DEVIATION REQUEST AND DECISION FORM

Project Name: Crossroads North

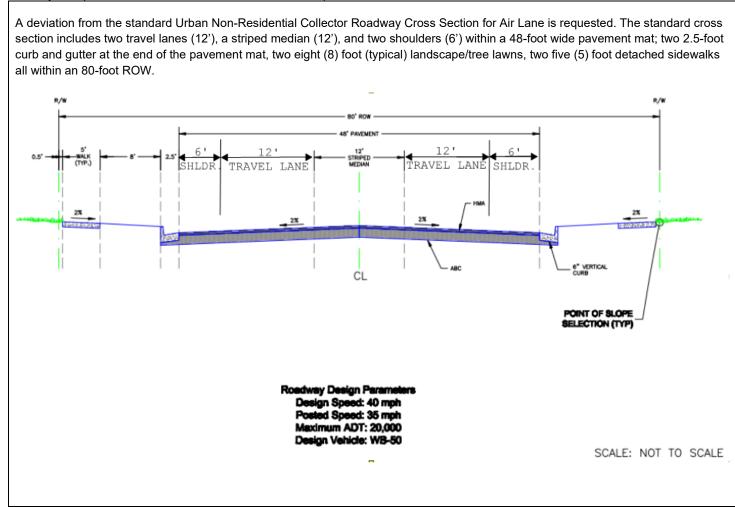
Revise. Air Lane is public road. Unresolved

Provide documentation that this P.I.E exist along the southside of Air Lane. If it doesn't then the development would need to acquire the necessary easement from the property before the deviation request would be approved.

Plat 1950 (attached) for Hillcrest Acres subdivision does not show this easement.
Unresolved.
